MEMORANDUM

From:	Built Heritage Officer		
Service	Green Infrastructure	App No:	242576
Address:	South Scarletts, Scarletts Lane, Hare Hatch, Wokingham, RG10 9XD		
Proposal:	Householder application for the proposed erection of a single storey side extension following the demolition of the breakfast room.		
Heritage Assets:	Scarletts – Grade II listed building Listed buildings along with conservation areas are classed as designated heritage assets under the NPPF (2024) and in the Council's Local Plan policies.		
Site Visit Made:	Yes

Proposed Internal East Elevation
Scale 1:20

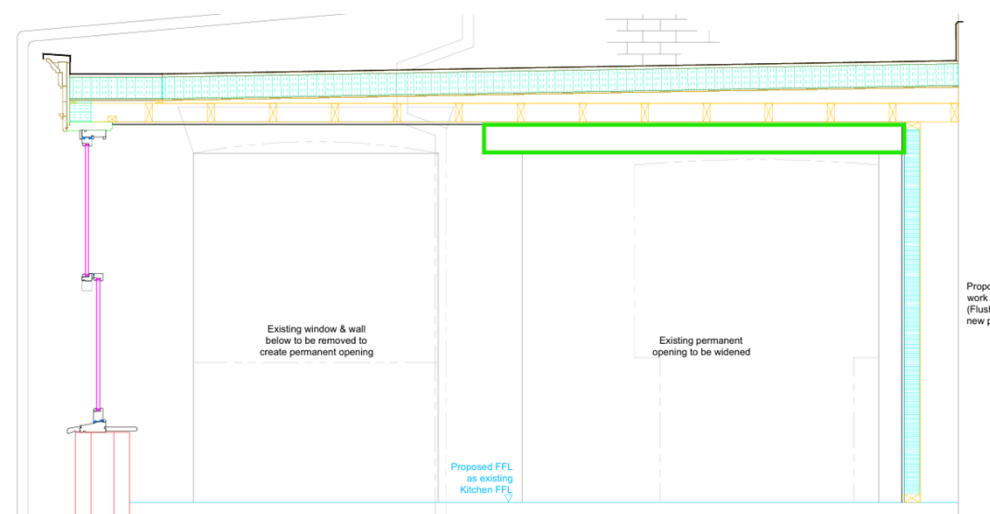
- Details concerning the two rainwater downpipes have now been clarified and acceptable, under drawing 12940/10A and 12940/09B
- Section drawing ref 12940/11A has been submitted in regard to structural steel to be inserted as to support the enlarged opening. However, this drawing implies the loss of the brick arch above the extant window if the steel is the span the whole width (red shape added to drawing 12940/10A to indicate steel):

- As drawing 12940/11A shows, the cross section of the steel is almost the full depth of the walling, and as (presumably the bricks for the arch have a standard c10mm measurement) there wouldn't be enough room to retain the arch and insert the steel – is this the proposal? Or is it proposed to only span the newly increased opening and not the window – something along the lines of this (green shape added to indicate steel):

Proposed Internal East Elevation
Scale 1:20

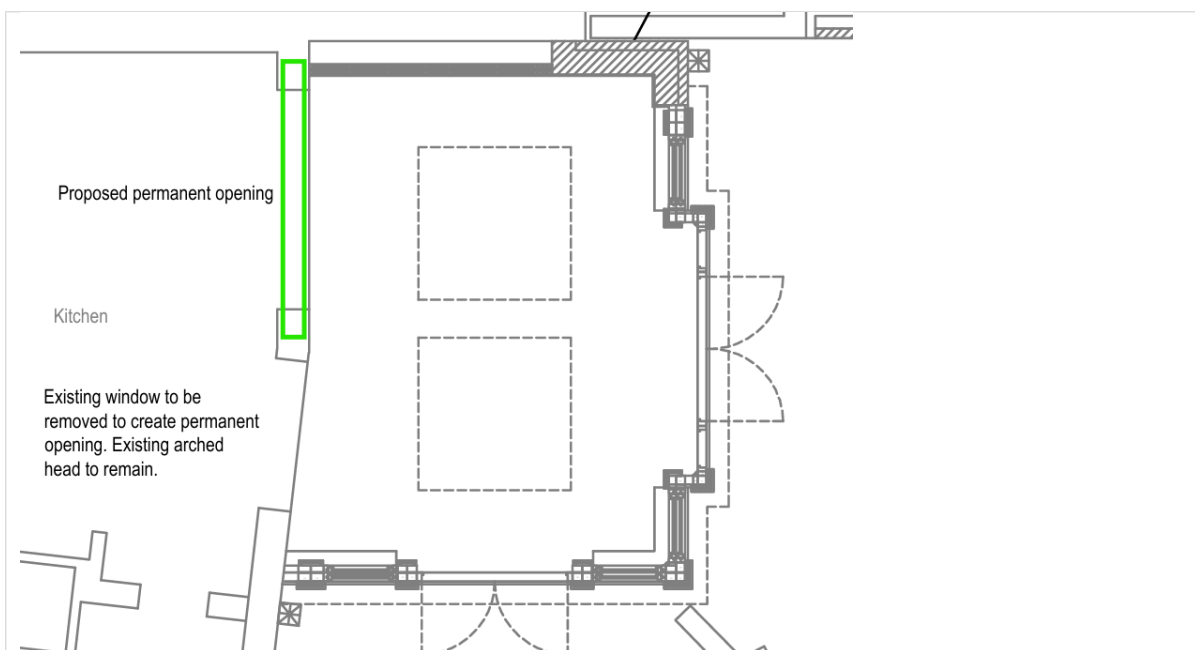
- If this latter option is the proposal, please could the drawings be revised as to include this for absolute clarity. As the walling kinks off, it is presumed a single span wouldn't work here in any regard. Furthermore, as the brick arch of the window is designed to take the load, and only a limited additional load is being proposed to be added, it – presumably – has sufficient structural capacity as extant.
